Docket No.: 50-322

SUBJECT: BOARD NOTIFICATION 85-009
EXEMPTION FROM GENERAL DESIGN CRITERION-17
REGARDING LOW POWER OPERATION OF THE SHOREHAM
NUCLEAR POWER STATION

Single Failure Concerns
Alternate AC Power Supplies
Shoreham Nuclear Power Station - Unit 1
Docket No. 50-322

FIG. 8.2.1-1
 MAIN LINE DIAGRAM
 SHOREHAM NUCLEAR POWER STATION-UNIT 1
 FINAL SAFETY ANALYSIS REPORT

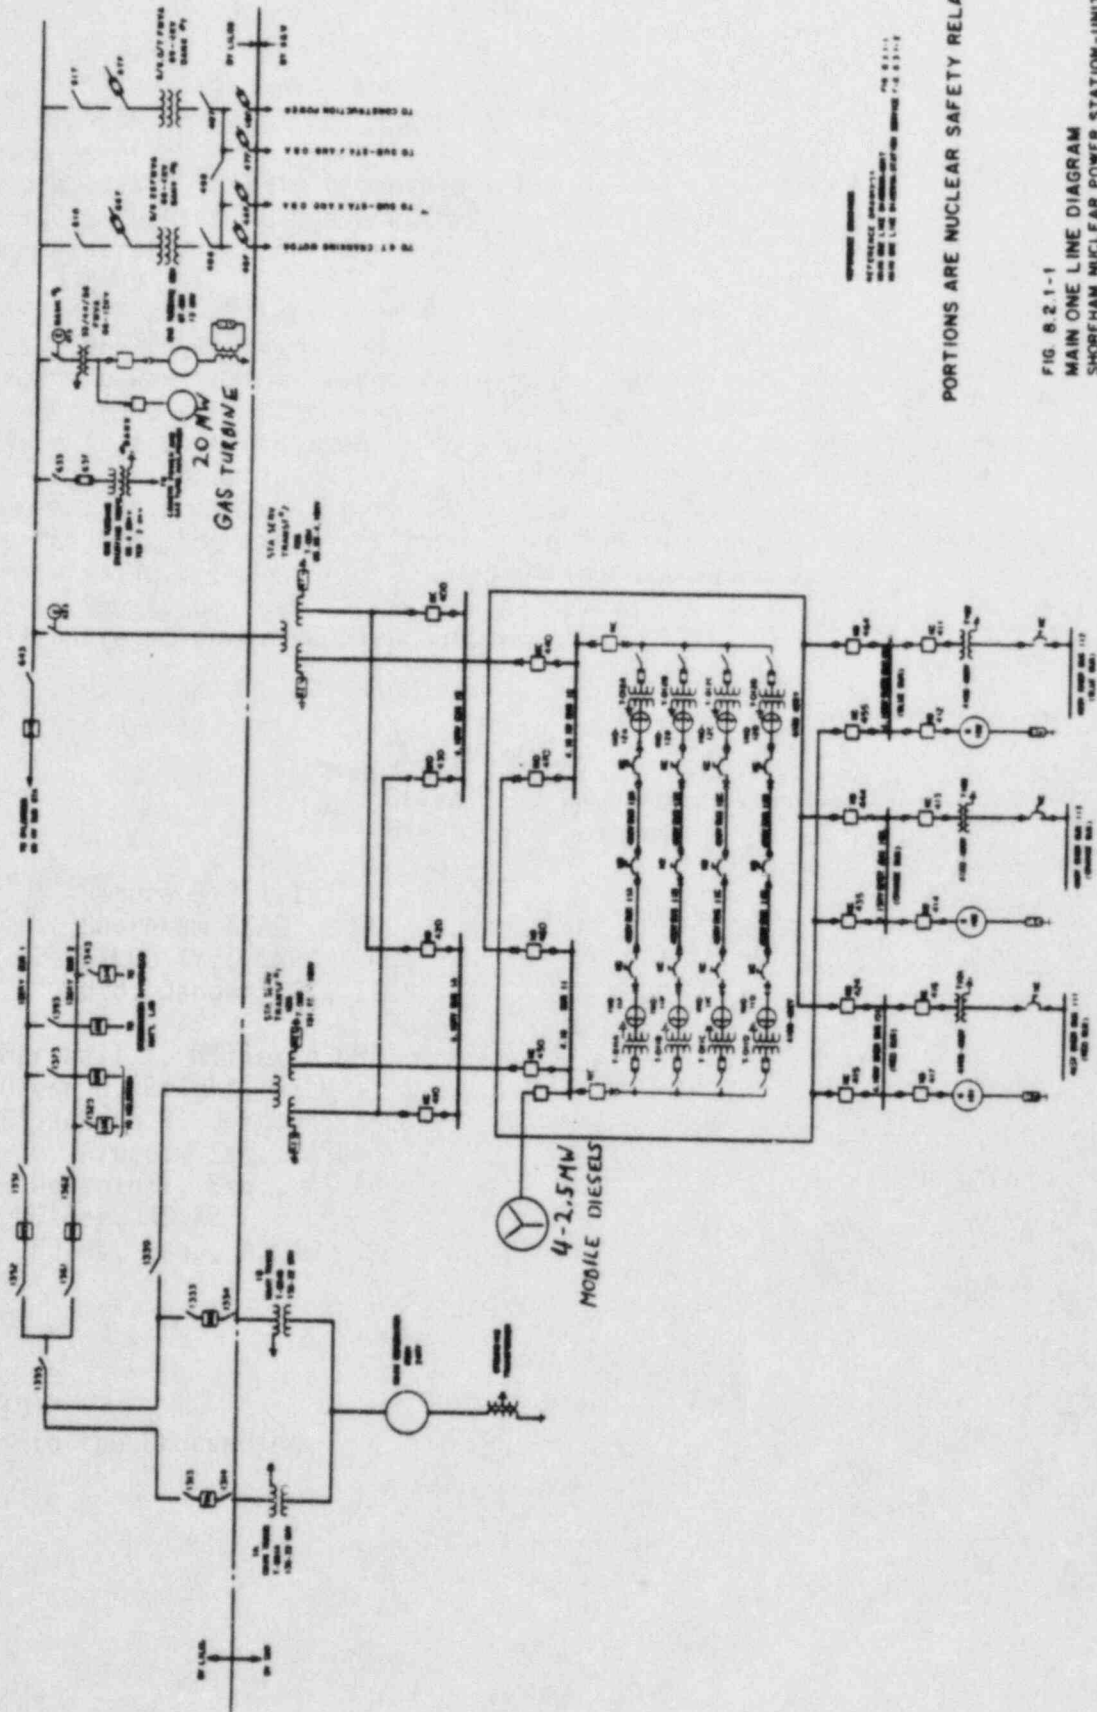
Upon reconsideration of the electrical distribution system at Shoreham, the staff has determined that there does exist the possibility of a single equipment failure which could disable both alternate sources of ac power (see the enclosed figure from the Shoreham FSAR). As defined for purposes of evaluating the request for exemption, the staff considered the occurrence of a LOCA coincident with a loss of both off-site sources of ac power from the LILCo grid. Further, because of uncertainties concerning their reliability, it was assumed that none of the three TDI Emergency Diesel Generators would be available to start. The licensee proposed that in this circumstance, power would be supplied from a 20 MW, dead-line, blackstart gas turbine generator which would feed the Reserve Station Service Transformer (RSST), and through it, the safety related emergency busses through breakers 424, 444, and 464; in the case of failure of the gas turbine, power would be supplied from four 2.5 MW mobile diesel generators, through Bus 11, and breakers 450, 415, 435

and 455. When SSER6 was written, however, it was not realized that if a fault in breaker 460 were to occur, such a fault could prevent power from reaching the emergency busses. This is because breaker 460 is common to both the power path from the gas turbine to the emergency busses, and to the path from the mobile diesel generator to the emergency busses.

The staff discussed this matter with the licensee, which provided its response on January 29, 1985 (see Enclosure 2). The licensee reported that it would be able to route power to the emergency busses by using an alternate path through the offsite distribution system. The licensee further committed to physically rack down breaker 460, thereby physically removing the possibility of the failure described above. The staff has reviewed the licensee's response, and has determined that if breaker 460 is racked down, the alternate ac power sources meet the single failure criterion, and the conclusions stated in SSER6 remain valid. The staff would condition the Shoreham license to require breaker 460 to be racked down during operation up to five percent power using the alternate ac power supply configuration.

Breaker number 460, the reserve station service transformer supply breaker to bus 11, is normally open. This reserve station service transformer supply breaker and all other interconnecting tie supply breakers on buses 1A, 1B, 11 and 12 are normally open and the verification of this is required per Shoreham Nuclear

Power Station Technical Specification 4.13.1.1.2.a.6. First, the fault postulated by the Staff on normally open breaker 460 is not a credible failure mode. It has been our experience that electrical faults, such as the one being postulated by the Staff do not occur when the breaker is in the open position. As noted above, the open status of the breaker is verified periodically per the technical specifications. Thus, it's not credible to assume that the breaker fails in this mode while it is open.

Second, even if a fault occurred as postulated in tie breaker number 460 it is still possible for the 20 MW gas turbine to supply power to Shoreham. In such an event, the EMD diesels could not be connected to the failed bus 11 and the failure of breaker number 460 would also cause a trip of the RSST protective relays which would trip all 7 RSST 4 KV breakers, the 69 KV switchyard supply breaker 640 and the 20 MW gas turbine breaker. The Plant Operator can open ABS 623 and the 4KV switch gear breaker 450 thereby isolating bus number 11 and the faulted 4 KV breaker 460. The Plant Operator can then reset the RSST lock out relay 86T4B, thereby allowing the 20 MW gas turbine to start in a dead line mode. The System Operator, by rearranging system breakers, can reroute power from the gas turbine via the 69 KV system and the 138/69 KV step up transformer at the Wildwood substation on the Shoreham property to the Shoreham 138 KV switchyard. Power is then connected to the emergency 4 KV bus from the normal station service transformer.

Despite our systems ability to overcome this highly improbable multiple contingency event we heraby commit to rack down 4 KV breaker number 460 to eliminate the Staff concern. We anticipate that this commitment should fully resolve this concern. Given that the postulated failure is highly unlikely, that there are ways to route power from the 20 MW gas turbine, even if it occurred, and that LILCO has made the above commitment with respect to breaker number 460, we trust that there is no need to change previous Staff positions on this subject.
